No. 1051
ATA Code 52-10

SUBJECT: DOORS - REPLACEMENT OF THE DOOR LOCK ASSEMBLIES

EFFECTIVITY: BEECHCRAFT Duchess 76, serials ME-1 through ME-6 and ME-8 through ME-115.

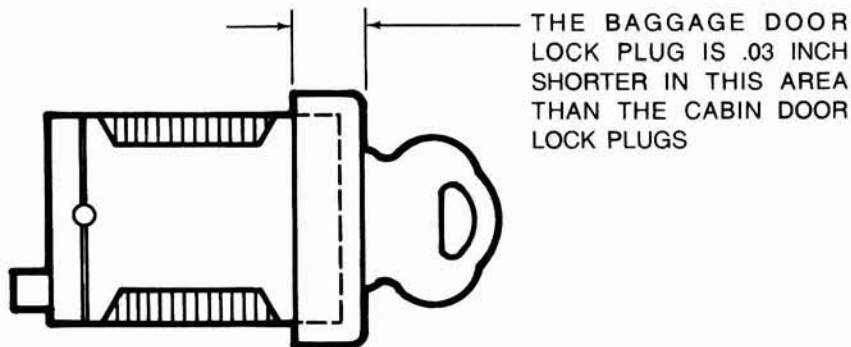
The baggage door lock plug has .03 inch trimmed off of the plug island to provide a better fit (see illustration).

Before installing the new lock plugs, insert the new keys and carefully file off any tumblers which may protrude from the plug.

3. Install the new baggage door lock plug in the baggage door outer handle assembly.
